**Re: Kimber Residence  
0 Pinecrest Parkway**

This letter is to request that the Steep Slopes and View Preservation Review be continued at the February 16, 2020 meeting of the Planning Board.

- A. An alternative design for the house consisting of three sheet of drawings prepared by Gotham Design & Community Development Ltd. under the review of Laura Wakefield, R.A., dated as submitted January 30, 2020, for the Planning Board.
- B. A Narrative documenting the fact that the subject property has steep slopes and making a request for a Special Hardship Exception from the Planning Board to permit the limits stipulated in the Code under Section 240-5.A. to be exceeded.

SHEET TITLE:  
**ELEVATIONS**

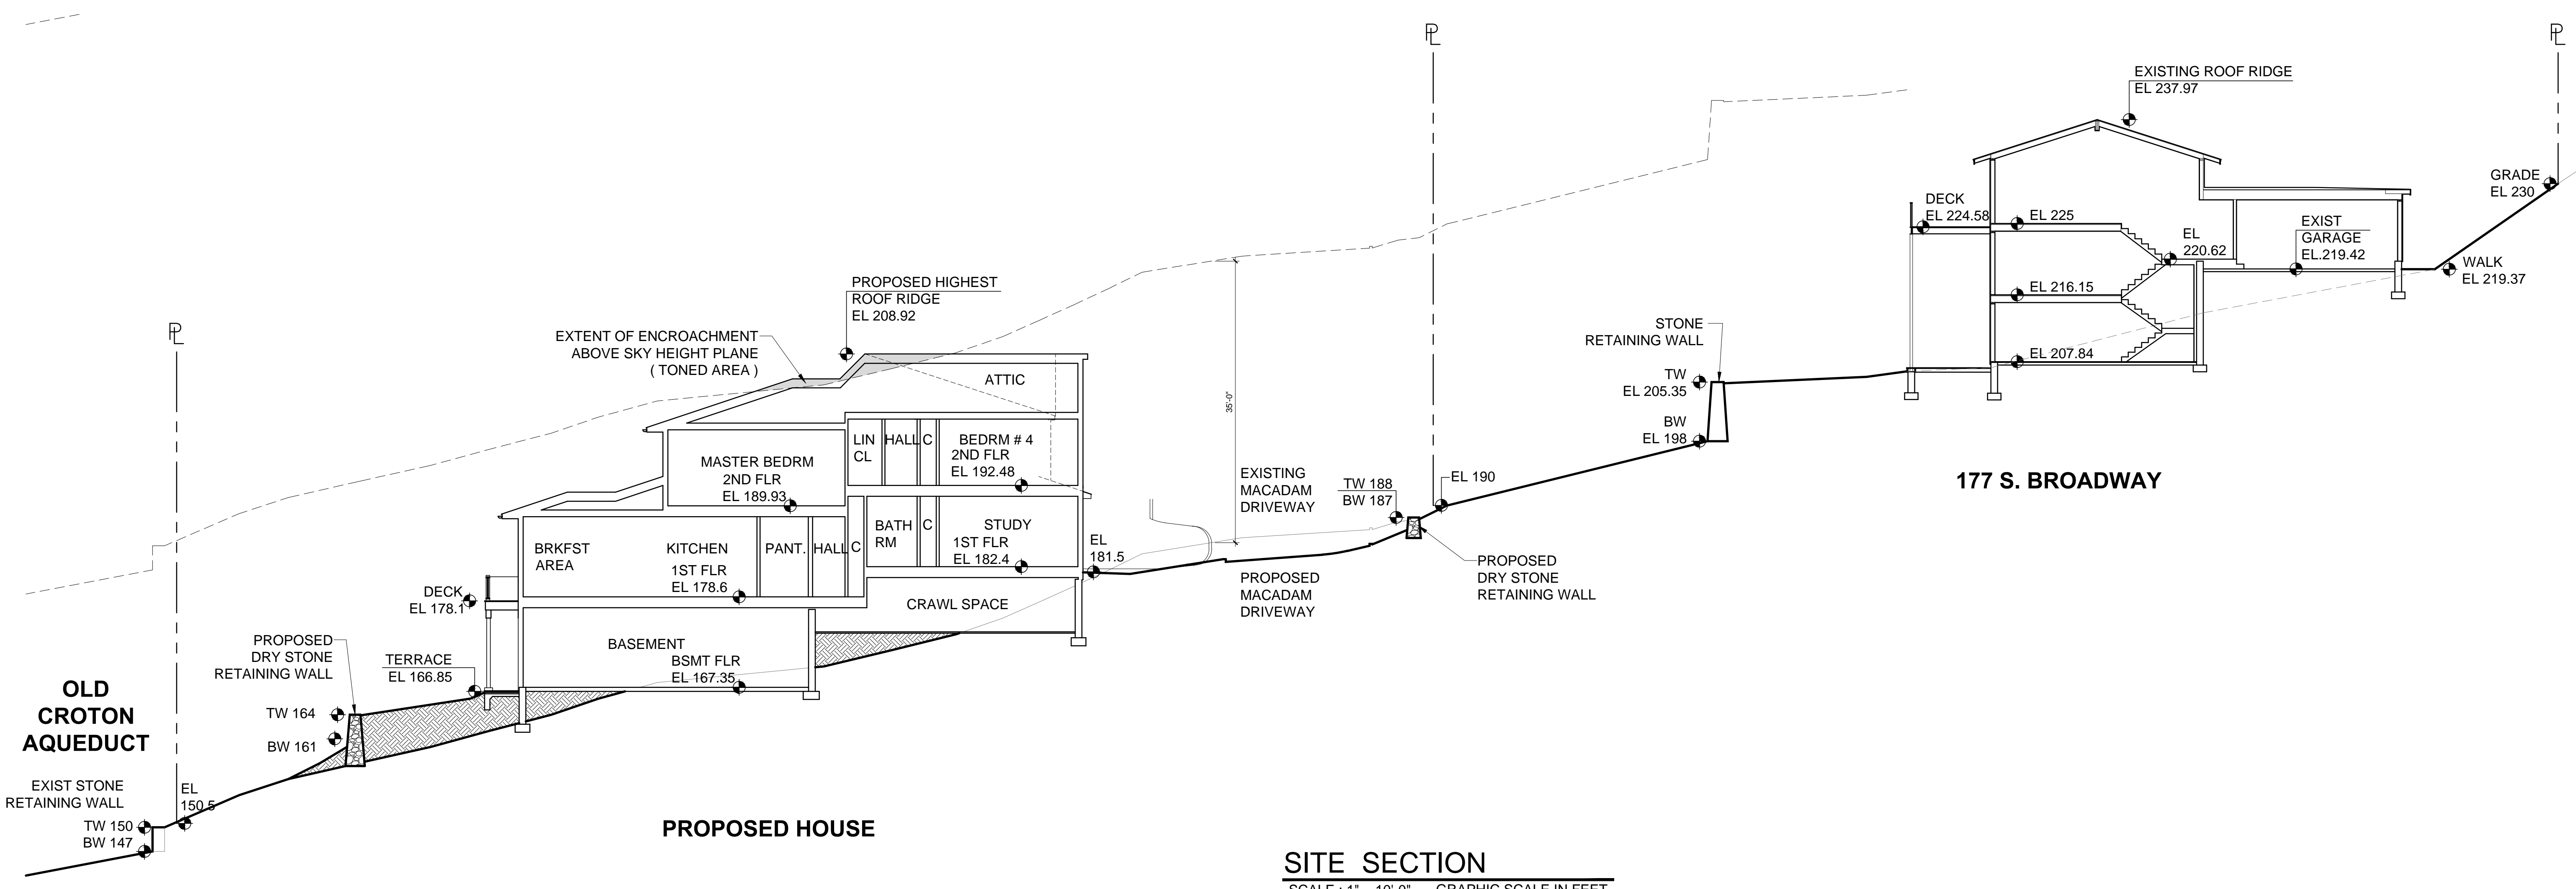
5. The height of the house has been reduced from a ridge elevation of 209.29 feet to a ridge elevation of 208.92. There is still a technical encroachment above the 35 foot sky plane, but as noted at the meeting, this is not a result of the house projecting higher but of a small area of the site dropping into the ravine lower. The grade at the front of the house is at approximately el.182, which makes the height of the house to the highest point of the ridge 26 feet as measured at the front. For comparison, the existing house at 115 Pinecrest Parkway has a ridge elevation of 208 with the grade at the curb at elevation 181. By contrast the existing curb elevation in front of the proposed house is elevation 185. (See Note 8 below).
